CDM: Response form for request for clarification on Approved Methodologies (version 01.1)

<i>Date of Meth Panel meeting:</i>	15 - 19 October 2012
<i>Title and number of request for clarification</i>	Conversion from single cycle to combined cycle power generation AM_CLA_0238

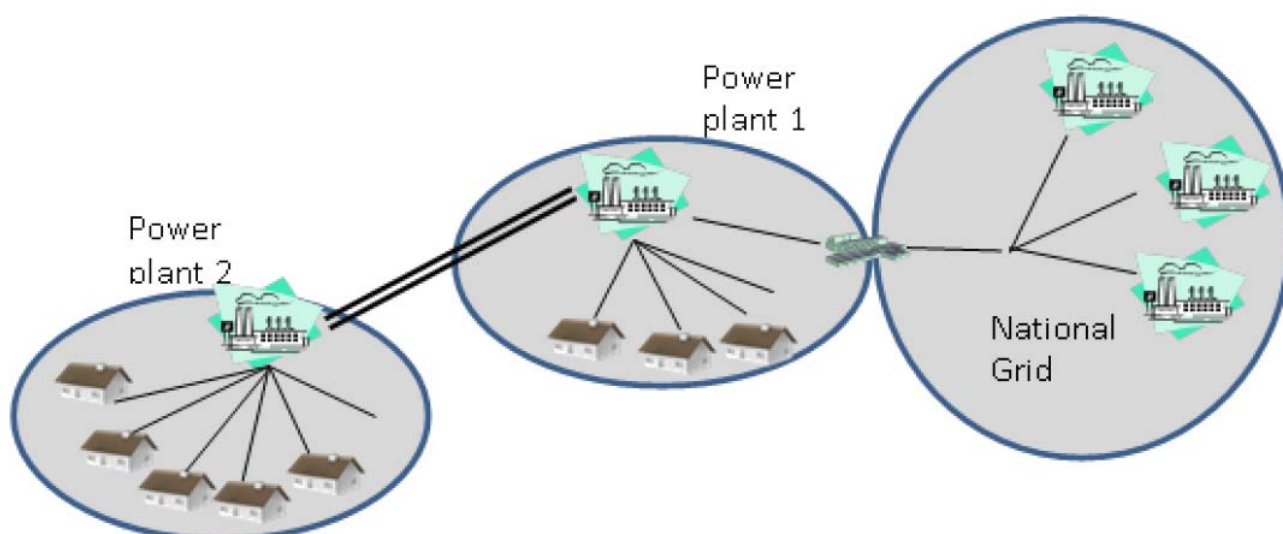
The clarification refers to a proposed project activity including two power plants which are inter-connected, but only one is connected to the grid, and that through a third power plant. Furthermore, the connection between the two plants did not exist prior to the implementation of the project activity. The following diagram illustrates the power connections.

1. Whether two power plants with the same owner but 40 km apart can be considered one project activity, considering that the methodology requires, in its applicability criteria, the power units to be at “one site”.

2. Whether power plants can be considered grid connected if they are connected to the national electricity network via a connection point at a captive power plant of a local consumer. In the project case, power plant 1 is connected to the grid in such a manner, whereas power plant 2 is only connected to power plant 1.

1. The two power plants being 40 km apart clearly put them in two separate sites. The methodology applicability criterion is specific in this regard and requires that the conversion from single cycle to combined cycle occurs at one site. Therefore the current version of the methodology does not include the scope of this suggested project. The two sites should be considered as two distinct projects.
2. Power station 2: From the clarification submission it seems that power station 2 is not connected to the national grid and functions as a captive power plant. Footnote 2 in the methodology states the following: "No provisions are provided to apply this methodology to captive power units in order to keep the methodology simple. If required, project participant may submit a request for revision to this methodology to apply it to captive power units."

Power station 1: Though power station now could be considered grid-connected, the methodology does not cover the scenario where a power plant is connected to a system other than the national grid prior to project implementation, because there is no provision in the methodology to consider the impact of the project on the supply of electricity to these systems after project implementation. A request for revision should be considered if this scenario is to be included in the methodology.
3. The methodology requires three years operational data at the implementation of the project activity or at the beginning of the validation, whichever occurs first, for at least one unit at the site.
4. The PDD can and should include calculations for all three cases. The appropriate case shall be selected and justified during validations.
